**FINDINGS OF FACT
FLORENCE PLANNING COMMISSION
EXHIBIT A**

Meeting Date: June 13, 2023

Application: PC 22 21 PUD 01, PC 22 23 SUB SUB 02, & SR 22 48 SIR 13 – Myrtle Glenn

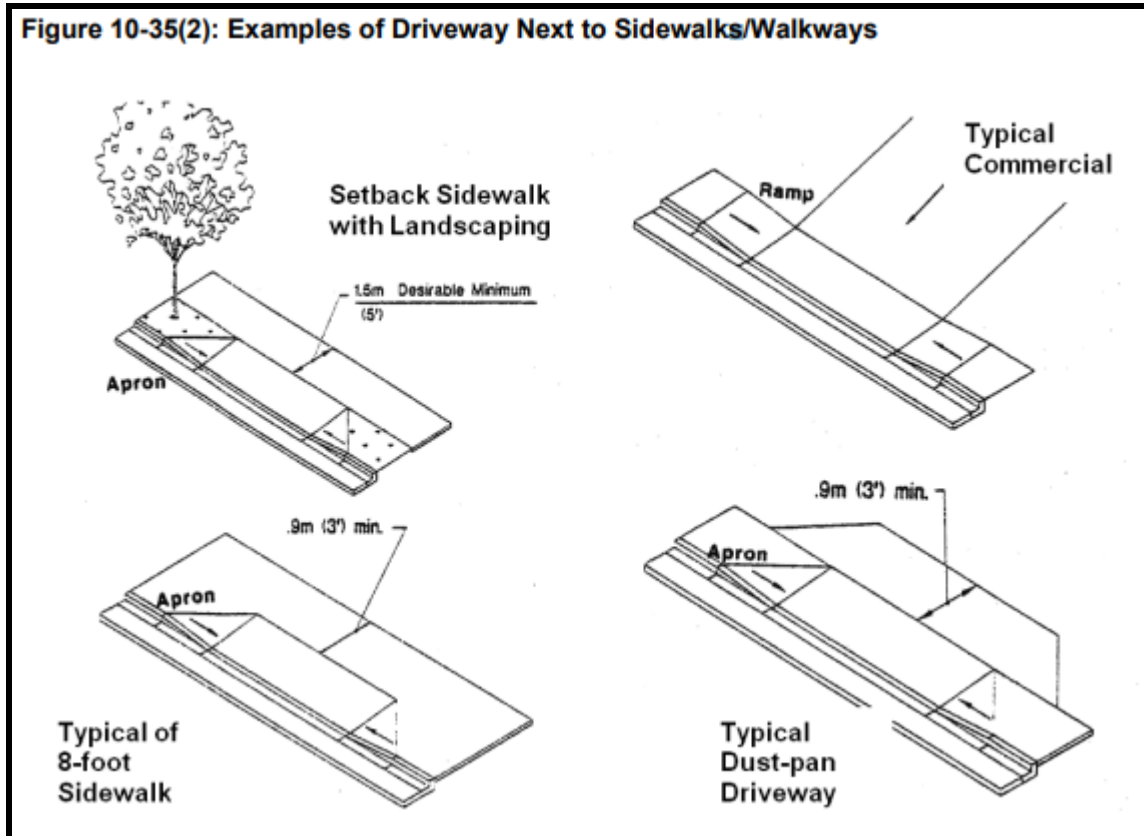
The driveway access points from 37th St into the shared parking area is proposed at 30 feet in width which exceed the maximum allowed 24 feet in width allowed under this code section. The applicant has not requested a modification for this variation in driveway width. Therefore, the maximum width shall be 24 feet and the minimum width shall be 18 feet to allow for two-way traffic circulation proposed by the applicant (**Condition 8.2**).

The grade of the drive way access was not included on the Tentative Access and Parking Plan Sheet 3 of Attachment 1 (**Exhibit C1**). However, the only significant slopes on the site are on the vegetated hill on the western portion of the property. It is not anticipated that the drive way grade will reach or exceed the maximum 15% grade. These code criteria are either met or are conditioned to be met.

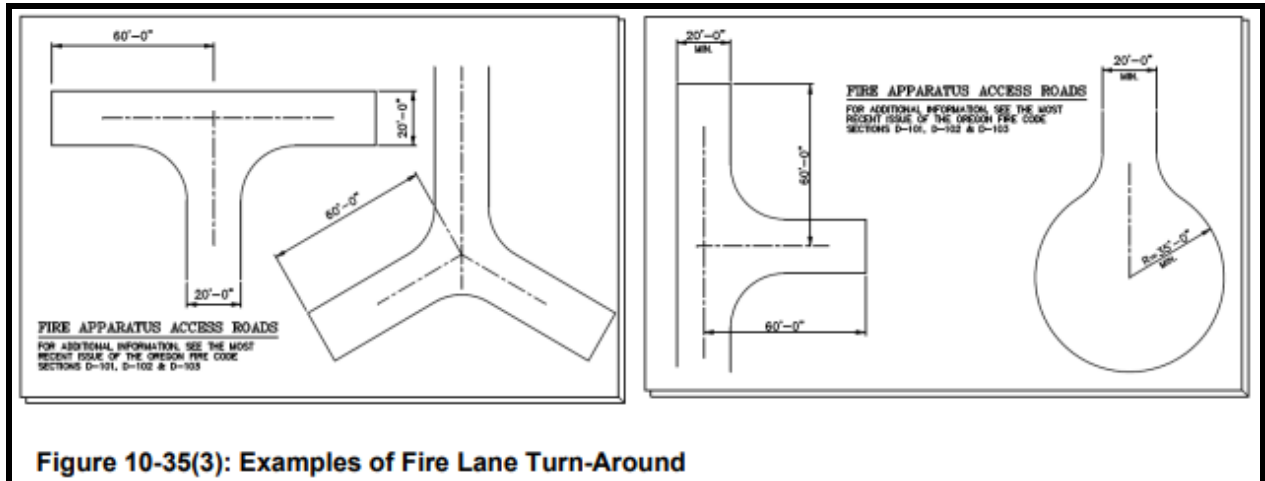
The applicant had proposed a fire access turn around location on the south west portion of 37th St approximately 70 feet from the west driveway access point (please see image below) on Sheet 3, Attachment 1 (**Exhibit C1**). The dimensions of the proposed turn around meet fire codes and SVFR Fire Chief reported in his referral comments that this meet fire code requirements.

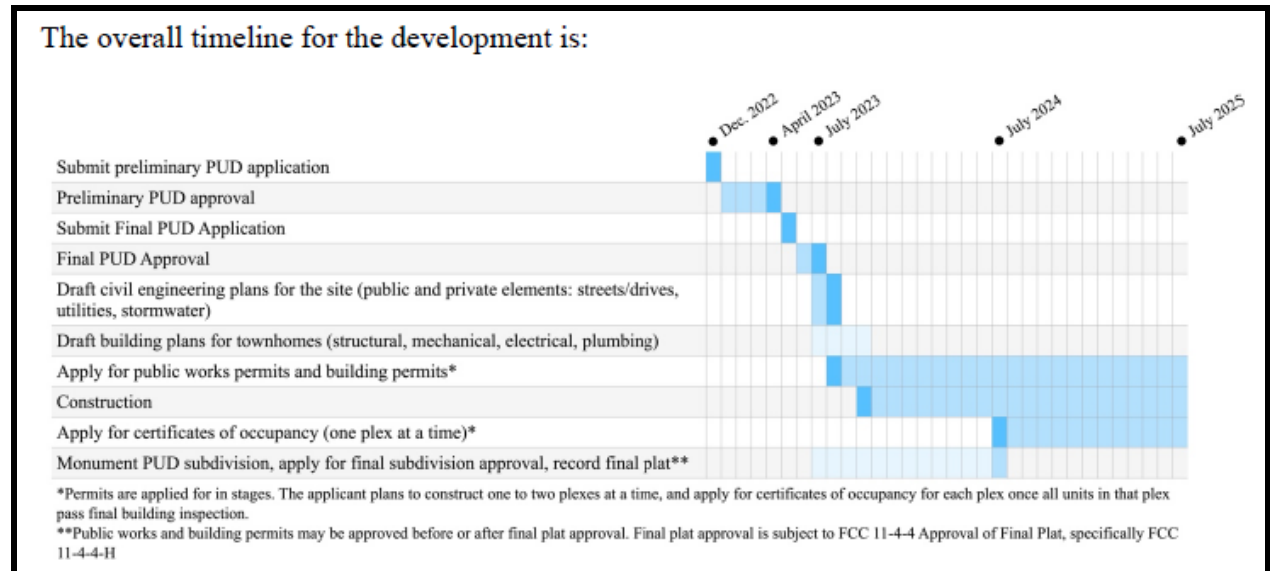
Flood control and easements for drainage facilities were included on Sheet 4 of Attachment 1 **(Exhibit C1)**. Public Work Director and Civil West Engineer comments are included in **Exhibit M**

Public Works Comments on these plans were that the Stormwater report should be approved, and the private stormwater facilities will need to be approved and inspected as each lot is built out. The referral comments state that beyond stormwater no other public utility plans were seen. Public Works Director provided comments as seen on Exhibit M.

All final engineering details and plans are subject to review, revision and approval by the Florence Community Department, Public Works Director and or City Engineer. The applicant shall submit all required sewage disposal, flood control, and drainage facility plans prior to final plat **(Condition 11.3)**. These criteria are either met or conditioned to be met.
